CITY CENTRE, SOUTH & EAST PLANNING AND HIGHWAYS COMMITTEE 5 NOVEMBER 2012

ENFORCEMENT REPORT

BREACH OF CONDITION 2 OF PLANNING PERMISSION 07/02026/FUL AND THE UNAUTHORISED ERECTION OF A SINGLE STOREY EXTENSION TO THE REAR OF 29 RATCLIFFE ROAD

Site Plan

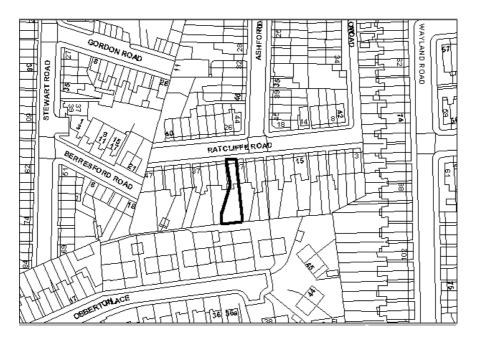
- 3. ASSESSMENT OF BREACH OF CONTROL
- 3.1 The extension is more than half the width of the original property and extends beyond the rear wall causing overshadowing of the single storey extension to number 31. This is considered to be contrary to the UDP Policies H5 (b) and H15 (c); and Supplementary Planning Guidance 'Designing House Extensions Guideline 5' (See photographs 1 2).

- 3.2 The extension has a side window that directly overlooks the immediate rear of number 27 resulting in a loss of privacy; and, therefore, considered to be contrary to UDP Policies H5 (b) and H14 (c); and SPG Guideline 6 (See Photograph 3).

- 3.4 The extension's stark appearance is considered as causing visual harm to the amenities of the street and to be contrary to UDP Policy H14.
- 4. ASSESSMENT OF ENFORCEMENT OPTIONS

- 7. RECOMMENDATION
- 7.1 That the Director of Development Services or Head of Planning be authorised to take any appropriate action including, if necessary, enforcement action and the institution of legal proceedings to secure compliance with Condition 2 of planning permission 07/02026/FUL; and to secure the removal of the unauthorised rear extension at 29 Ratcliffe Road.
